CITY OF CAMBRIDGE, MASSACHUSETTS

PLANNING BOARD

PRELIMINARY DETERMINATION

Case No: 222
Address: 22 Water Street
Owner/Applicant: Catamount Holdings, LLC, 90 Everett Avenue, P O Box 9252, Chelsea, MA 02150 9252
Application Date: November 21, 2006
Date of Preliminary Determination
Public Hearing: December 19, 2006

PERSPECTIVE STUDY

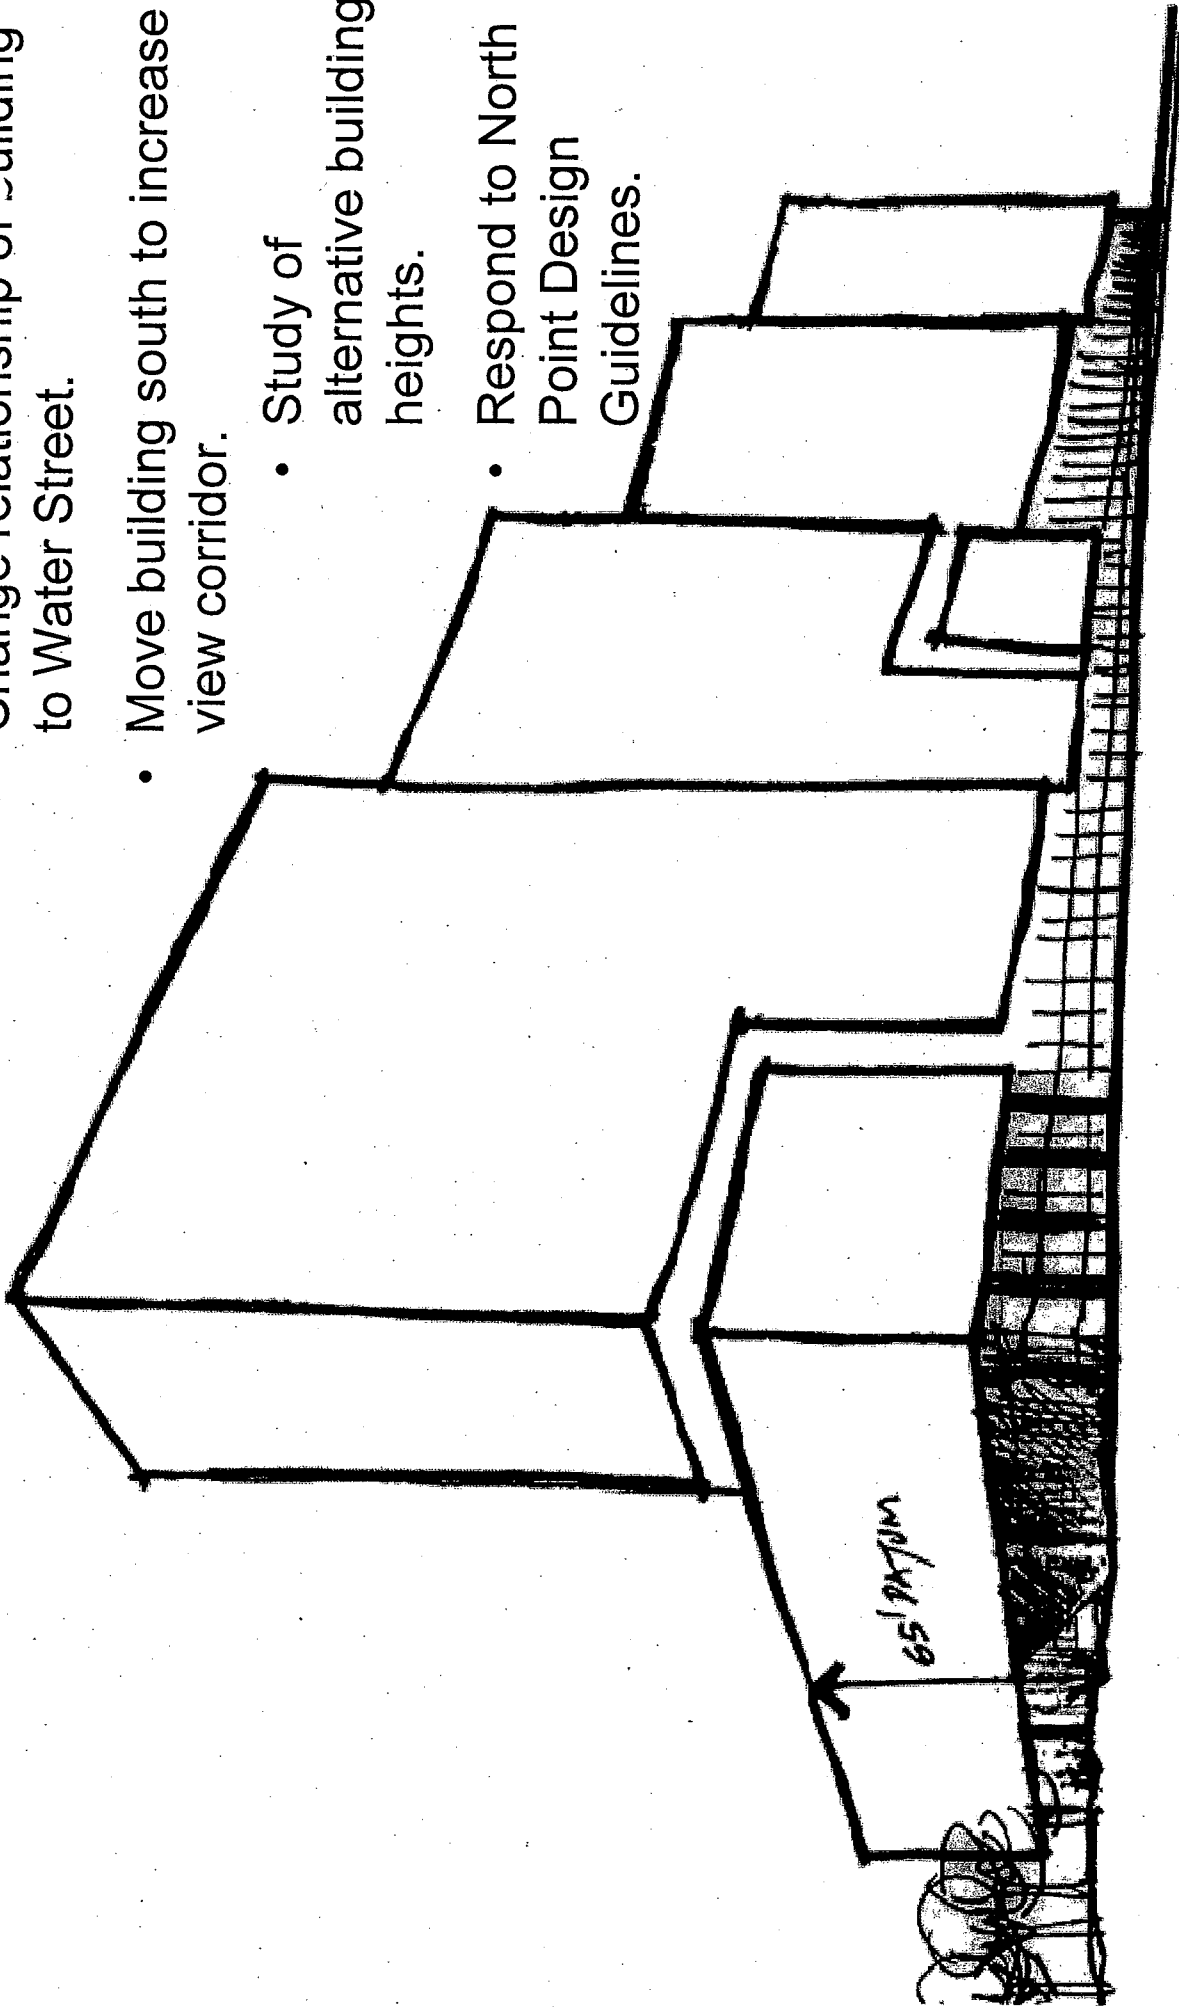
- The perspective study, which begins to introduce a 65' height marker, is responsive to the Board's earlier concern. Particularly on Water Street, the 65' block will potentially provide a much better relation between the street and the building. On the North Street side, the sketch is less clear—more significant use of the 65' height is needed here, with some regard for the future relationship to sites A and B of PUD Special Permit #179.

- The intent to go back to an earlier idea of having the taller blocks in combination with other blocks of lesser height, with only a few elements above the allowed height, is welcome. The Board has said that some height at 150' may receive their support at the Board of Zoning Appeal, but it is clear that the entire building at 150' is unacceptable.

- Change relationship of Building to Water Street.

- Move building south to increase view corridor.

- Study of alternative building heights.

- Respond to North Point Design Guidelines.

SITE CIRCULATION STUDY

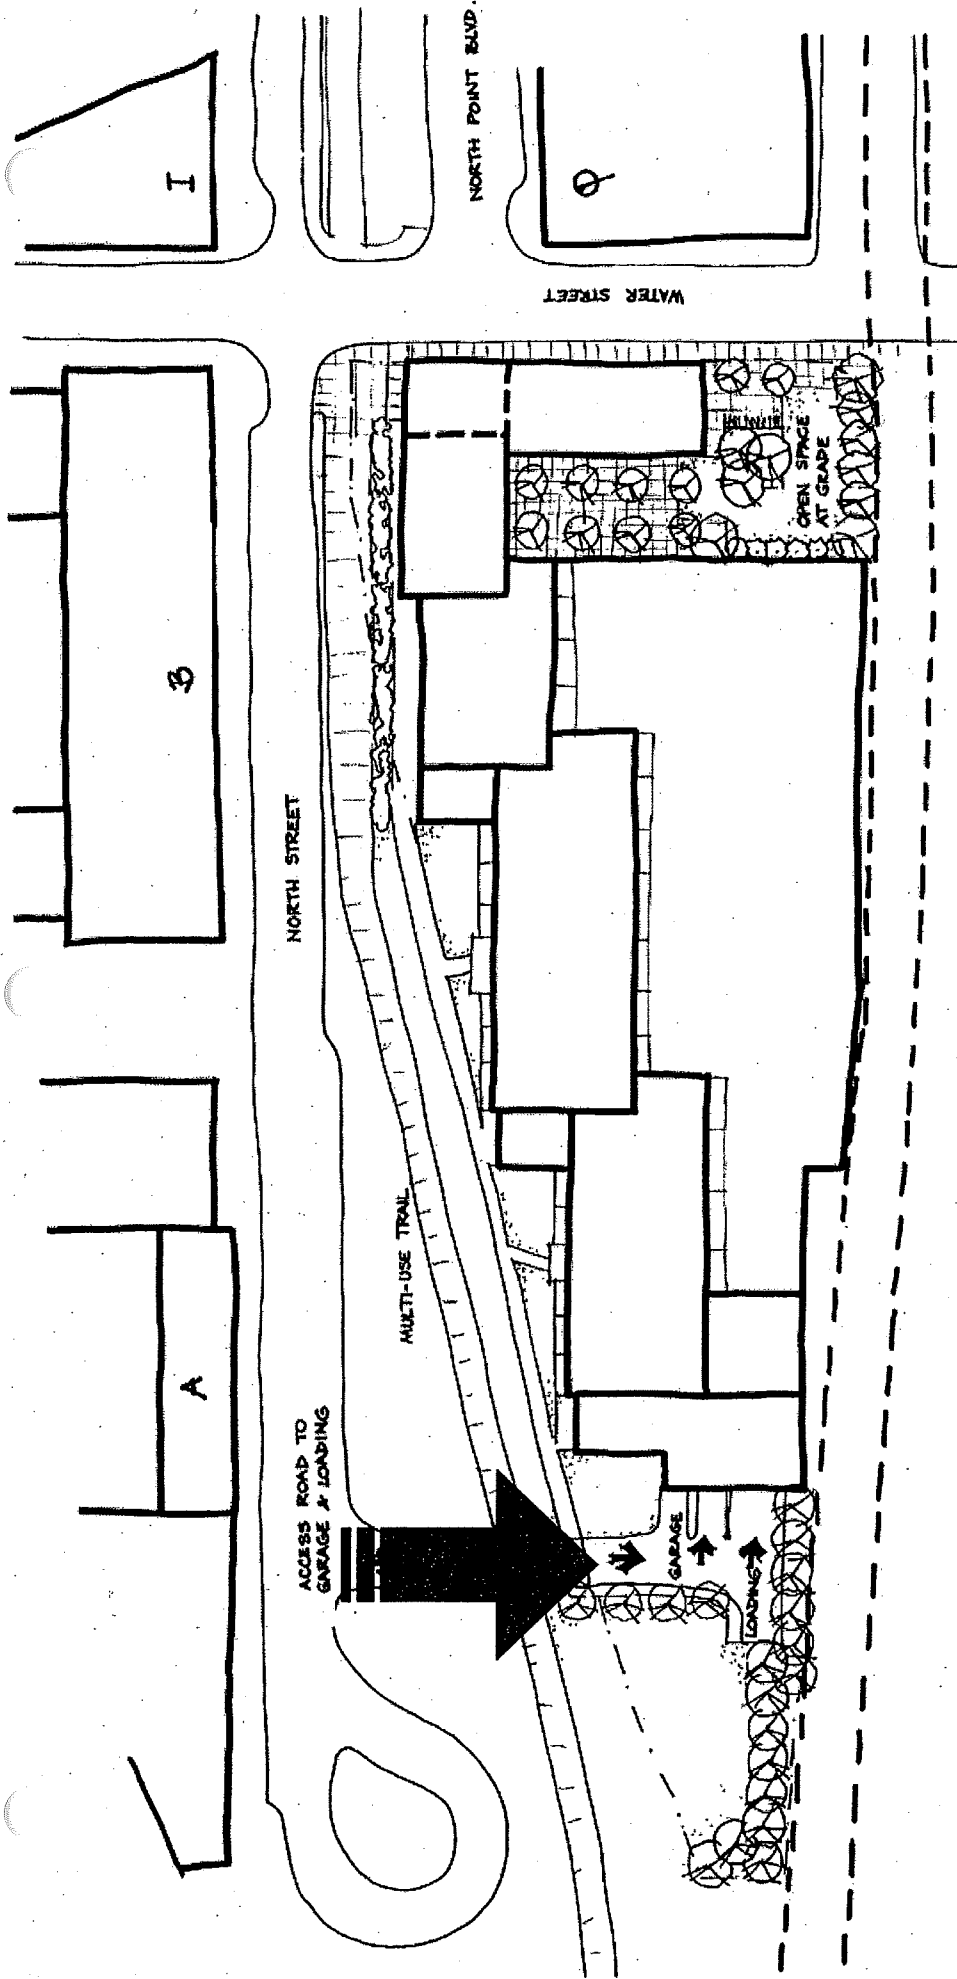
- The Board indicated that a particular concern is the nature of the North Street and other access ways, again in relation to PUD Special Permit #179. Significant reconfiguration that does a better job of continuing the boulevard treatment to the west would be important.
- In a related fashion, the Board is not convinced that the diagrammatic shifting of the easternmost block element of 22 Water Street will be sufficient; it may need to shift further to the south.

- The move of the garage entry and loading to the west is very much what the Board suggested. The associated landscaping and screening will need to be coordinated with the roadway redesign.

- The suggestion of at-grade open space along Water Street is a move in the right direction, though its design will require special thought as to how to mitigate noise, etc. in relation to the transit activities at site Q of PUD Special Permit #179 and along the rail viaduct.

- Even though the replacement of the "Terrace Park" with the "Open Space At Grade" is likely to be a good change, the garage roof that would remain still needs design attention. It would be useful to consider whether a "green roof" treatment might be effective here.

- Increased space for alignment of multi-use trail.
- Alternative garage & loading access.
- Coordination with North Point Master Plan (JLL).
- Elimination of curb cuts on Water Street.
- No vehicle queuing on Water Street.
